SOUTH PLANNING COMMITTEE

SCHEDULE OF ADDITIONAL LETTERS

SOUTH PLANNING COMMITTEE		
SCHEDULE OF ADDITIONAL LETTERS		
Date: 22 nd July 2014		
<p>NOTE: This schedule reports only additional letters received before 5pm on the day before committee. Any items received on the day of Committee will be reported verbally to the meeting</p>

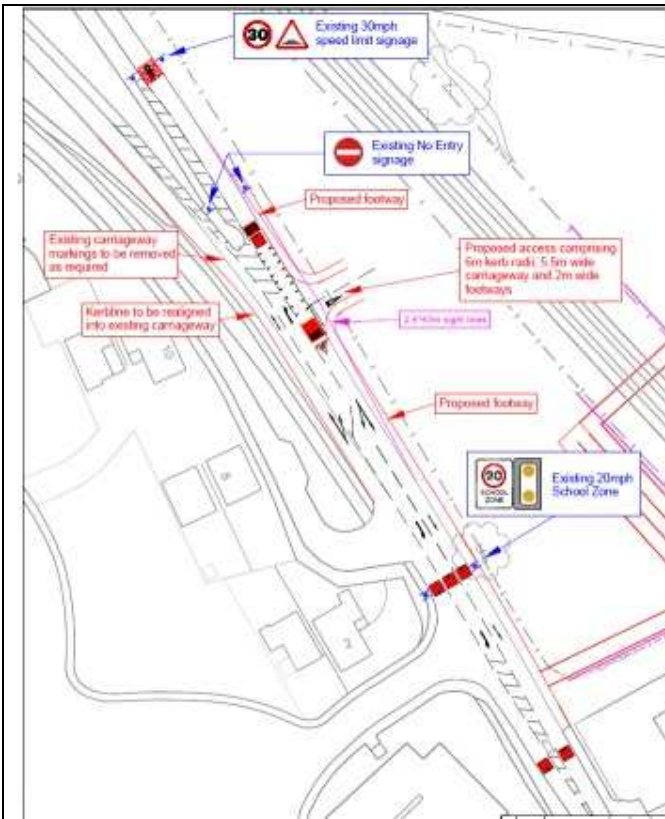
The applicant has confirmed the layout of the proposed roundabout on the A49 and that this has been agreed in principle by the Highways Agency. A vertical alignment plan has also been provided and will be made available at the committee site visit:

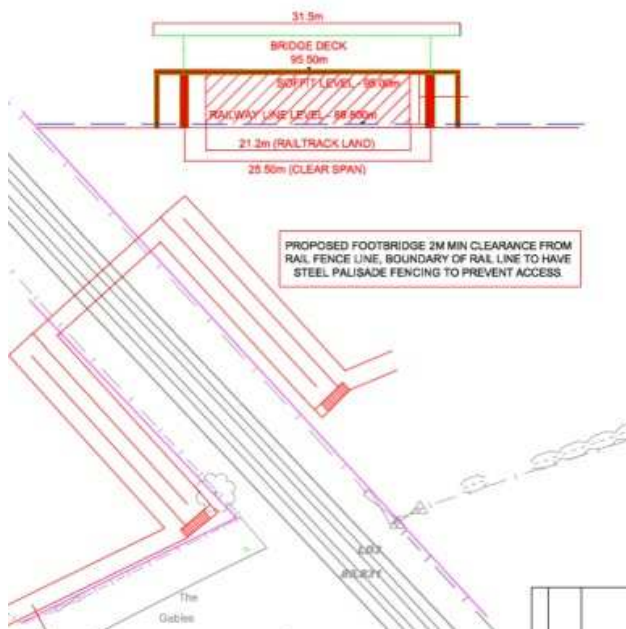
The applicant has provided confirmation of the junction layout for the site at Bromfield Road and the associated safety signage. This has been discussed with the Council's Highways officers.
